**PRM 50-93
(75FR03876)**

COMMENTS ON PRM-50-93 AND PRM-50-95; NRC-2009-0554

COMMENTS ON PRM-50-93 and PRM-50-95; NRC-2009-0554

Appendix A Figure 4-1. Comparison of Thermal Response of PWR-FLECHT and Reactor Fuel Rods¹

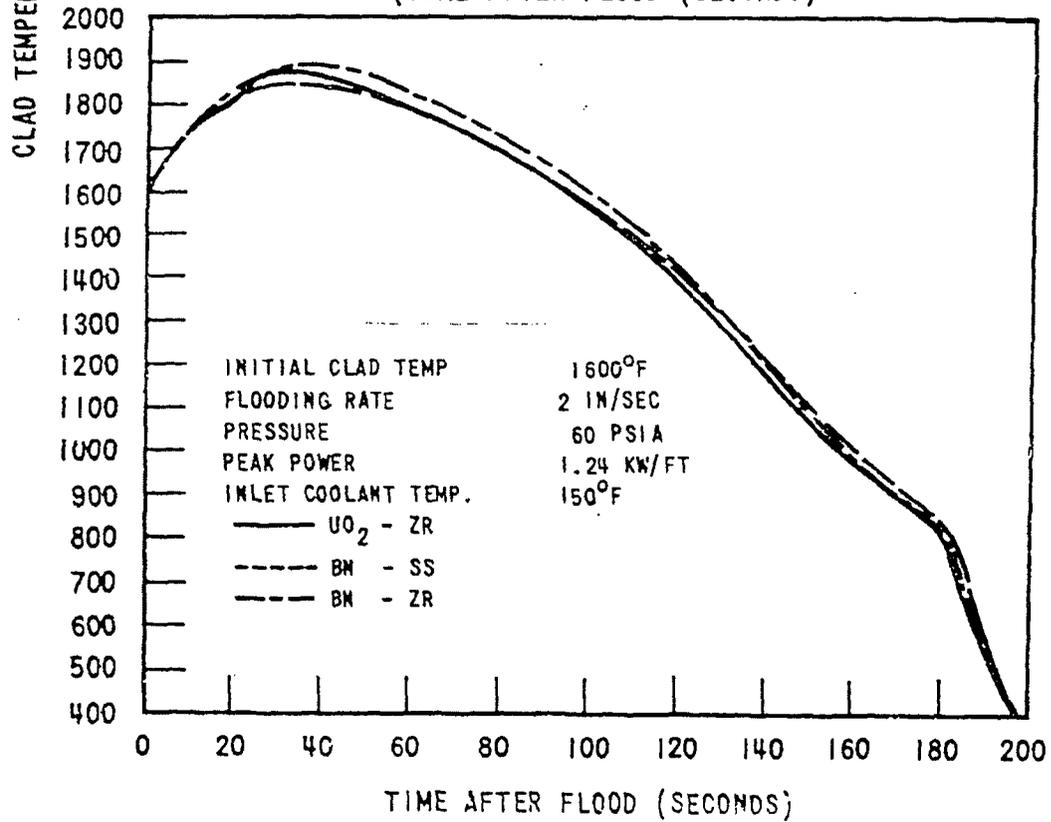
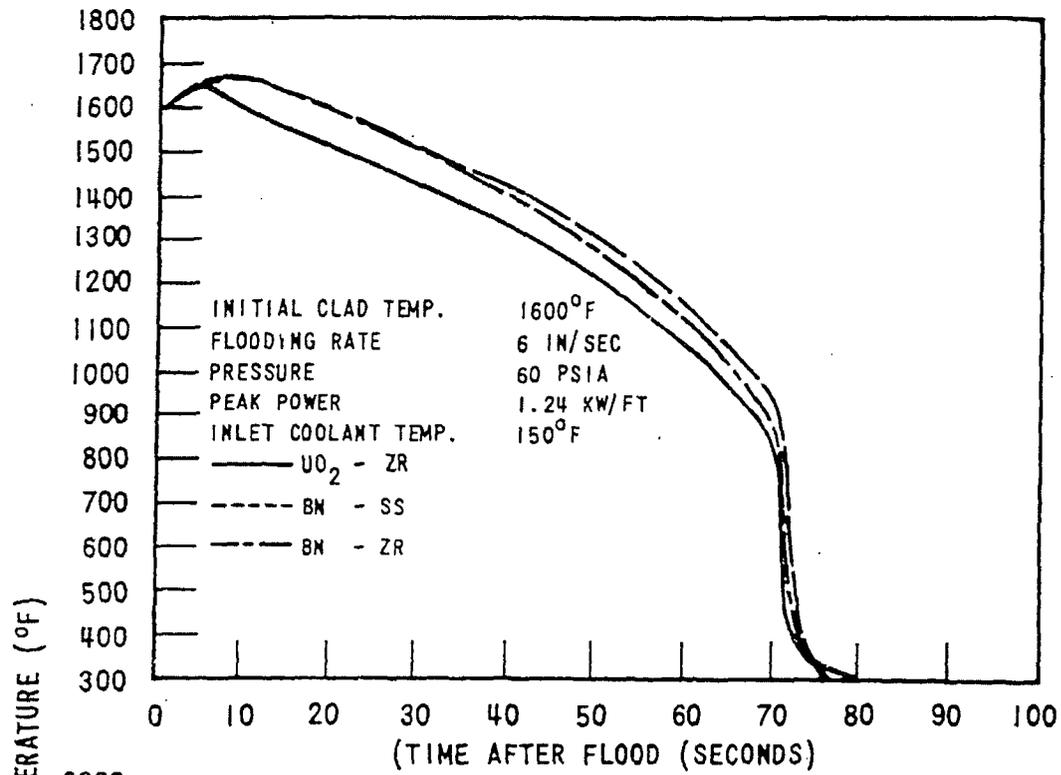
In TH-1 test no. 128, with a peak power of 0.55 kW/ft,¹⁴ a reflood rate of 2.0 in./sec., and a PCT at the onset of reflood of 1604°F, the overall PCT was 1991°F (an increase of 387°F).¹⁵ And in the “PWR FLECHT Final Report” example, the UO₂ Zircaloy fuel assembly, with a peak power of 1.24 kW/ft, a reflood rate of 2.0 in./sec., and a PCT at the onset of reflood of 1600°F, was predicted to have an overall PCT of approximately 1880°F (an increase of approximately 280°F).¹⁶

So with similar parameters (but with a lower fuel rod power) TH-1 test no. 128 had an overall PCT increase that was more than 100°F greater than the overall PCT increase predicted in the UO₂ Zircaloy fuel assembly example discussed in “PWR FLECHT Final Report.” This indicates that analyses using the Baker-Just correlation under-predict the amount of heat that Zircaloy oxidation generated in TH-1 test no. 128, a thermal hydraulic experiment simulating LOCA conditions.

Figure 4-1²⁸ shows a comparison of the temperature response of boron nitride-stainless steel (BN-SS), boron nitride-Zircaloy (BN-Zr), and uranium dioxide-Zircaloy (UO₂-Zr) rods for 6 and 2 in./sec. flooding rates. The curves were generated by a conduction code using heat transfer coefficients obtained from stainless steel PWR FLECHT tests.²⁹ The gap coefficients for the BN and UO₂ cases were 10,000 and 500 Btu·hr⁻¹·ft⁻²·°F⁻¹, respectively. Initial temperature distributions were assumed to be uniform in the BN cases, whereas a 59°F difference between peak pellet and initial clad temperature was used in the UO₂ cases. Metal-water reaction was predicted in the Zircaloy cases using the Baker-Just parabolic rate equation (reference 4).³⁰ The BN-SS curves are generally representative of the behavior of Group I and II PWR FLECHT heater rods and were found to be in good agreement with the measured temperature response for the same run conditions. The BN-Zr curves are representative of the behavior of Group III PWR FLECHT rods while the UO₂-Zr curves are representative of reactor fuel rod response, assuming the BN-SS heat transfer coefficients apply.³¹

Figure 4-1., “Comparison of Thermal Response of PWR-FLECHT and Reactor Fuel Rods,”³² depicts temperature plots of the BN-SS, BN-Zr, and UO₂-Zr representative

examples for the flooding rates of 6 in./sec. and 2 in./sec. Petitioner will only discuss the representative examples with the 2 in./sec. flooding rate.

For the BN-SS, BN-Zr, and UO₂-Zr representative examples, with the 2 in./sec. flooding rate, the maximum overall PCTs of all three representative examples are lower than 1900°F.

The UO₂-Zr representative example (with a temperature plot drawn with a solid line) has the middle overall PCT value of approximately 1880°F.

The BN-SS and BN-Zr representative examples have overall PCTs of approximately 1840°F and 1890°F, respectively.

Figure 4-1., "Comparison of Thermal Response of PWR-FLECHT and Reactor Fuel Rods" lists some of the parameters for the BN-SS, BN-Zr, and UO₂-Zr representative examples: initial PCT of 1600°F, flooding rate of 2 in./sec., pressure of 60 psia, peak power of 1.24 kW/ft, inlet coolant temperature of 150°F.
